# Access Compliance Report

## Public Rights-of-Way

### (Curb Ramps)

Intersection ID: 14213	Main Street: CENTRAL_AV	Cross Street: ROSEHAVEN_DR	Location: NE
ADA ID: 6912DFCE1B2B	Ramp Type: Para	Initial Pass/Fail: Fail	Overall Compliance: No
Codes/Mitigation Info/Possible Solution		Field Measurements/Component Compliance	
Severity Score: 13.75

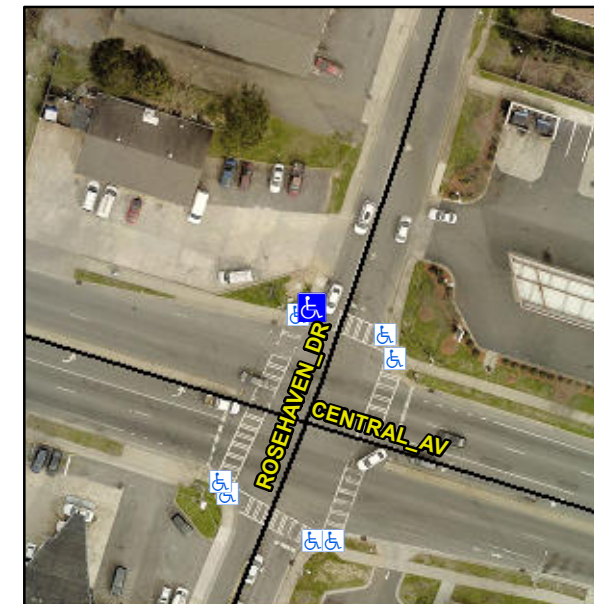
**LT RP < 5%**

**R304.5.3, R304.3.2**

Compliance	Description	Data	Compliance	Description	Data
N/A	Ramp Length LT (in)	45.5	N/A	Ramp Length RT (in)	55.5
Yes	Ramp Width LT (in)	72.5	Yes	Ramp Width RT (in)	71.5
Yes	Ramp Slope LT (%)	2.5	No	Ramp Slope RT (%)	9.0
No	Ramp XSlope LT (%)	4.7	No	Ramp XSlope RT (%)	2.1
N/A	Landing Length (in)	N/A	N/A	DWS Provided?	N/A
N/A	Landing Width (in)	N/A	N/A	DWS Contrast?	N/A
N/A	Landing Slope (%)	N/A	N/A	DWS Length (in)	N/A
N/A	Landing X Slope (%)	N/A	N/A	DWS Full Width?	N/A
N/A	Landing Curb? (Y/N)	N/A	N/A	DWS Offset (in)	N/A
N/A	Shared Landing?	N/A			
N/A	Gutter Ponding?	N/A	N/A	Gutter Slope (%)	N/A
N/A	Gutter Lip Ht (in)	N/A	N/A	Gutter X Slope (%)	N/A
N/A	Painted X Walk1?	Yes	N/A	Painted X Walk2?	N/A
	X Walk 1 Direction	To E		X Walk 2 Direction	N/A
N/A	X Walk 1 Width (in)	111.0	N/A	X Walk 2 Width (in)	N/A
	X Walk 1 Slope (%)	2.6		X Walk 2 Slope (%)	N/A
	X Walk 1 X Slope (%)	0.3		X Walk 2 X Slope (%)	N/A
N/A	Ramp inside XWalk1?	Yes	N/A	Ramp inside XWalk2?	N/A

**Remove & Replace Entire Ramp.**
